dsPIC33EPXXX(GP/MC/MU)806/810/814 and PIC24EPXXX(GP/GU)810/814 Family Silicon Errata and Data Sheet Clarification

The dsPIC33EPXXX(GP/MC/MU)806/810/814 and PIC24EPXXX(GP/GU)810/814 family devices that you have received conform functionally to the current Device Data Sheet (DS70616G), except for the anomalies described in this document.

Data Sheet Clarifications

The following typographic corrections and clarifications are to be noted for the latest version of the device data sheet (DS70616G):

FIGURE 16-2: HIGH-SPEED PWM MODULE REGISTER INTERCONNECTION DIAGRAM

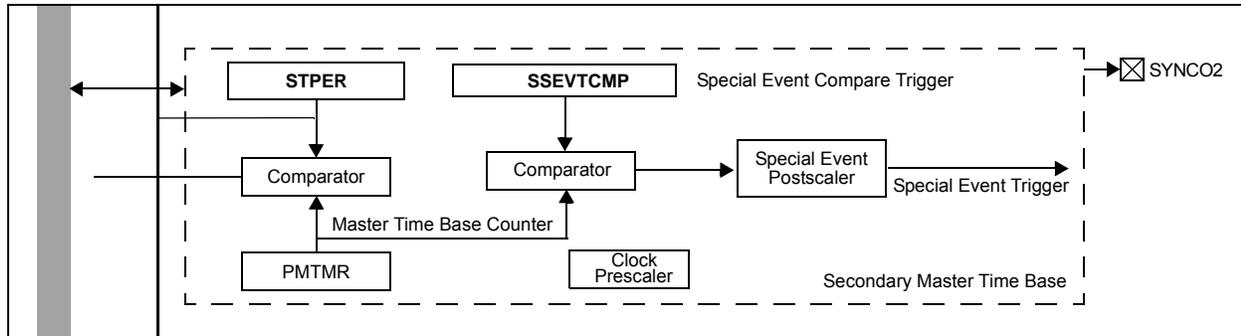
In **Figure 16-2: High-Speed PWM Module Register Interconnection Diagram**, the Secondary Master Time Base section has been updated. The updated text is shown in **bold** in [Figure 16-2](#) below.
